UNITED STATES PATENT AND TRADEMARK OFFICE

10/066,000

Office Action Summary	Application No. 10/066,000	Applicant(s) TSAI ET AL.	
	Examiner Michael A. Lyons	Art Unit 2877

DETAILED ACTION

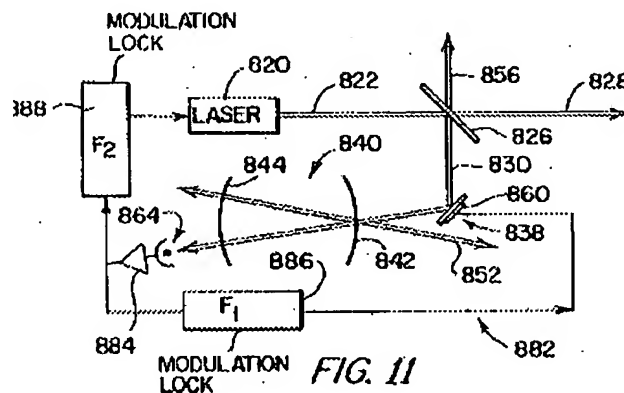
Regarding claims 1, 6, and 8, Dahmani (Fig. 11) discloses an apparatus and corresponding method comprising a first beam splitter 826 to separate out a portion of the input light beam, confocal etalon 840 to receive the sample beam, a photodetector 864 to receive the beam from the etalon, and a link in the form of an amplifier 884 and a pair of frequency modulation locks 886 and 888 to lock the frequency of laser 820 based on the signal received from the etalon.

As for claims 2, 3, 10, 11, 13, and 14, Dahmani discloses curved mirrors 842, 844, for example, as the plates that create the confocal etalon.

FIG. 2

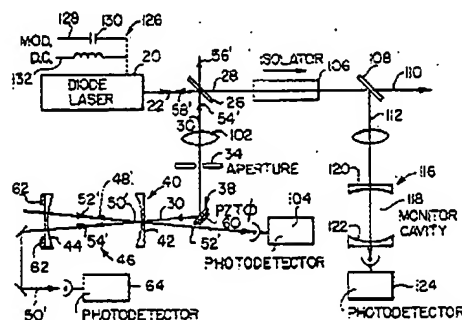
As for claims 5, 7, and 9, Dahmani, in an alternate embodiment (Fig. 2), discloses a second beam splitter 108 that receives a beam identical to the pre-etalon sample beam and a photodetector 124 that receives the signal after it passes through monitor cavity 118. While this isn't explicitly disclosed as a normalization signal, it would have been obvious to one of ordinary skill in the art at the time the invention was made to use the signal from this photodetector as a normalization signal, since the signal received by this photodetector is unaltered and would therefore provide a normal, reference-type signal. As for the links and processor, see the arguments above for claim 4.
